# UNITED STATES PATENT AND TRADEMARK OFFICE

APPLICATION NO	). I	FILING DATE	FIRST NAMED INVENTOR	ATTORNEY DOCKET NO.	CONFIRMATION NO.	
10/694,241 10/27/2003		10/27/2003	Paul Bentley	38398/284438	3741	
23370	7590	06/14/2005		EXAM	EXAMINER	
JOHN S. KILPATR			DINH, TIEN QUANG			
KILPATRICK STOCKTON, LLP 1100 PEACHTREE STREET ATLANTA, GA 30309				ART UNIT	PAPER NUMBER	
			3644			
	•			DATE MAILED: 06/14/2009	ς .

and :						
<b>,</b>	Application No.	Applicant(s)				
Office Action Summary	10/694,241	BENTLEY ET AL.				
Office Action Summary	Examiner	Art Unit				
	Tien Dinh	3644				
The MAILING DATE of this communication appears on the cover sheet with the correspondence address Period for Reply						
A SHORTENED STATUTORY PERIOD FOR REPLY IS SET TO EXPIRE 3 MONTH(S) FROM THE MAILING DATE OF THIS COMMUNICATION.  - Extensions of time may be available under the provisions of 37 CFR 1.136(a). In no event, however, may a reply be timely filed after SIX (6) MONTHS from the mailing date of this communication.  - If the period for reply specified above is less than thirty (30) days, a reply within the statutory minimum of thirty (30) days will be considered timely.  - If NO period for reply is

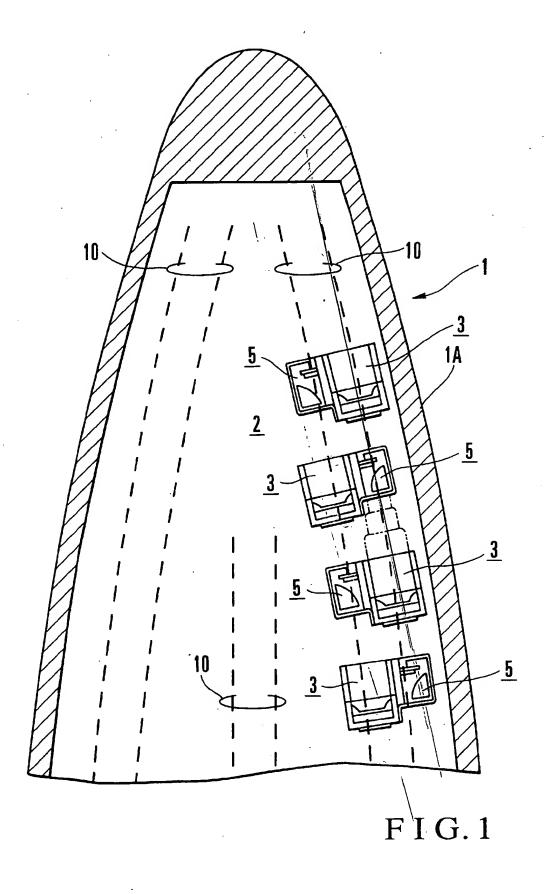
In response to applicant's arguments that Kitamoto et al shows a seat longitudinal axis is parallel to the track, the Examiner respectfully disagrees. Kimatoto et al clearly shows that track is not parallel to the seat longitudinal axis. This can be see in figure 1. The track 10 is clearly curved. When one draws a seat longitudinal axis, this axis clearly intercept the curved track. The definition of parallel is "being an equal distance apart everywhere." Clearly Kitamoto et al does not teach that track is parallel to the seat longitudinal axis. The Examiner attaches figure 1 with a red line designating the seat longitudinal axis. The red line intersects the track 10. The applicant also cited that column 3, lines 65-67 and column 4, lines 2-8 as evidence that the seat longitudinal axis and the curved track are parallel. This is not convincing since the cited lines do

not mention anything definitive about the seat longitudinal axis and the curved track being parallel. Kitamoto et al discloses what has been claimed.
